DOT/FAA/AM-95/18

A Human Factors Evaluation of the Operational Demonstration Flight Inspection Aircraft

HUMAN FACTORS CONSIDERATIONS OF THE MSR TECHNICIAN'S WORKSTATION

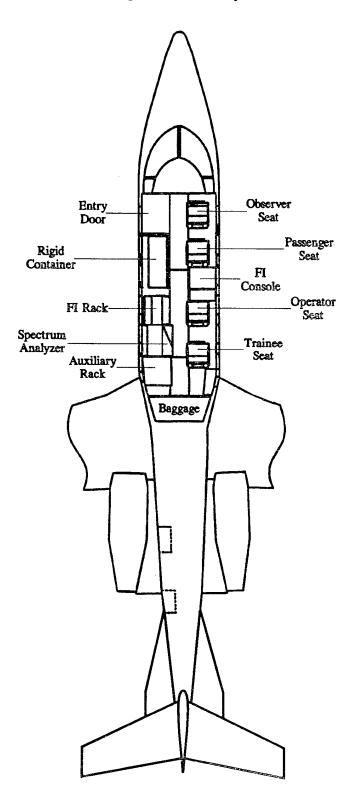
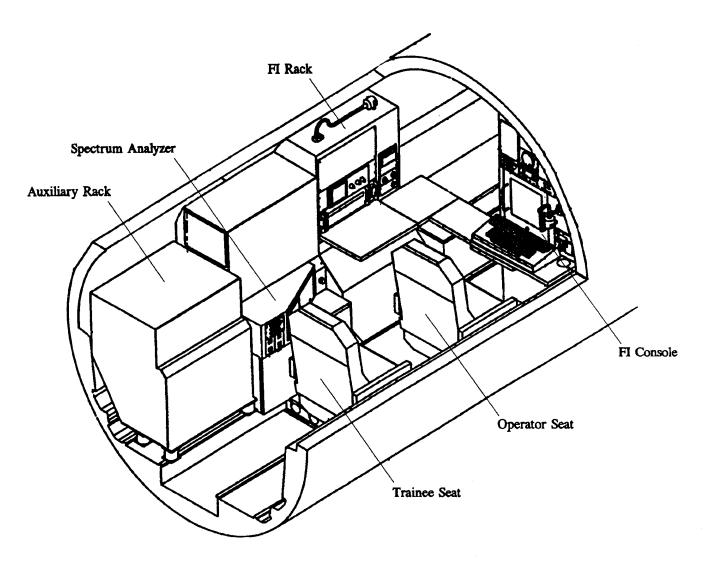
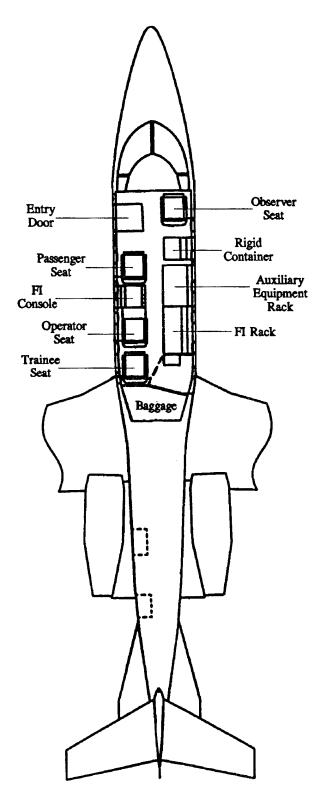
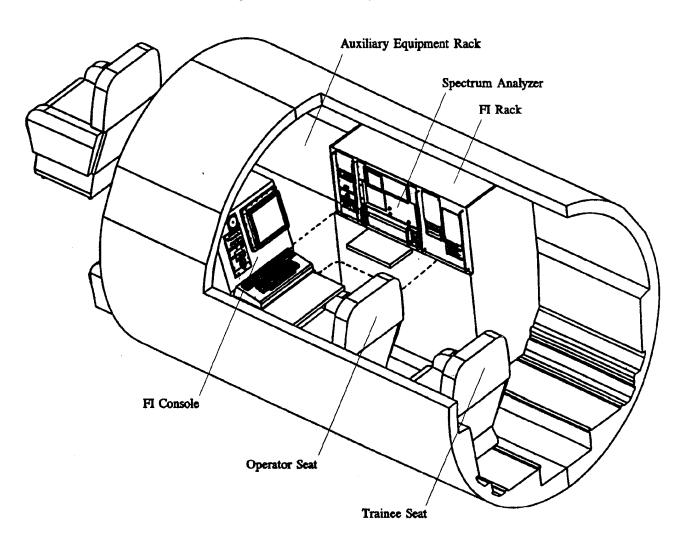
- The recorder was positioned in a manner that would make it difficult to write on its associated printout. It was positioned on the left of the aircraft, requiring right-handed technicians to reach across their bodies to annotate the printout when facing the plasma display.

- 2. The spectrum analyzer is positioned to the lower left of the forward-facing technician's seat. It is possible to position the display for this unit at a higher level on one of the two instrument panels for easier viewing. The control unit can be located remotely.

- 3. No provision for storage space for equipment and documents was indicated in the mock-up. The spectrum analyzer position, if fitted with a door, would provide adequate storage. This option depends on the spectrum analyzer display and control unit being moved, as suggested above in point 2.

- 4. The event marker should be placed closer to the surface, instead of above the plasma display, so the arm/hand has a place to rest.
- The cup holder location should be moved to allow for more writing space on the surface directly in front of the forward facing technician. If moved, it should not be placed where the recorder printout is annotated.

- The corners of the workstation shelves and pullout writing surfaces should be rounded to reduce the likelihood of injury.
- There was no indication of the headphone jack position in the mock-up. It should be positioned so as not to interfere with technician movement.

- 8. Windows are not proposed for installation on the right side of the aircraft cabin at the technician's workstation. It would be beneficial to provide the technician with these windows.

- 9. The workstation should be positioned on the opposite side of the aircraft to avoid the problem described in point 1. This would require the specification of the rigid container to be changed. The rigid container should not drive the design and layout of the technician's workstation.

- 10. If the recorder is moved below the plasma display, which is not recommended, it must be done so as not to cause the plasma display to be raised to an uncomfortable viewing angle.

- 11. The console containing the plasma display should be reduced in height to allow for forward viewing.
- 12. Although the revised design is considerably improved over the original design, it should not serve as a standard for other FIA systems installed in aircraft that allow for a truly forward facing work station. The current design has a forward seated console, a compromise to the specification to allow for the consideration of smaller aircraft. This design was a result of the decrease in floorspace associated with revisions in the specifications.

Based on the above considerations the contractor modified the design that had originally been proposed for integrating the flight inspection workstation into the aircraft. Each of the above points was addressed in the redesign of the revised workstation. Drawings of the original design and the design accepted by the agency are presented for comparison (Figures 8 through 11). Figures 8 and 9 detail the original aircraft cabin and technician's workstation layout, Figures 10 and 11 detail the design accepted by the agency for installation in the Lear 60 MSR FIA.

The main difference between the two layouts is the side of the aircraft on which the workstation is positioned. The original design proposal called for the workstation to be positioned on the left side of the aircraft, requiring right-handed technicians to reach across their body to annotate the recorder printout. The contractor initially did not suggest a right-handed workstation, since the size requirements for the rigid container restricted its placement in the aircraft cabin. It was suggested to AVN that the rigid container should not drive the design and layout of the technician's workstation. The rigid container specification was modified to allow for the repositioning of the workstation to the right side of the cabin. The suggestion to move the workstation to the right side of the air-

craft was incorporated into the design accepted by the agency It was contended that since the workstation had to be either right- or left-handed, it should accommodate the majority of the user population.

The only alternative to a right- or left-handed workstation was a design that incorporated the recorder/printer into the display console below the plasma display. Placing the recorder/printer below the plasma display was not acceptable for three reasons. First, the paper would spill into the technician's lap over the keyboard, making operation of the flight inspection equipment difficult. Second, the plasma display would need to be raised, potentially to an uncomfortable viewing angle. Third, it would not be possible to reduce the height of the console containing the plasma display to allow for forward viewing. The accepted design allows for forward viewing due to the reduced height of the display console.

The revised design places the spectrum analyzer in the flight inspection rack, where it can be easily viewed. The event marker was moved to a lower position near the keyboard so that the arm/hand has a place to rest. A provision was made in the display console for document storage. The cup holder was moved so that it does not reduce writing space. The edges of the workstation shelves and pullout writing surfaces were rounded to reduce the likelihood of injury. The headphone jacks were positioned to the right side of the technician's workstation. All usable windows (those not covered by flight inspection equipment) were added.

Second, the writing surface below the plotter (Figure 11) did not provide sufficient writing space for the technician. The contractor increased the size of the writing space from that shown by the solid lines to that shown by the dotted lines.
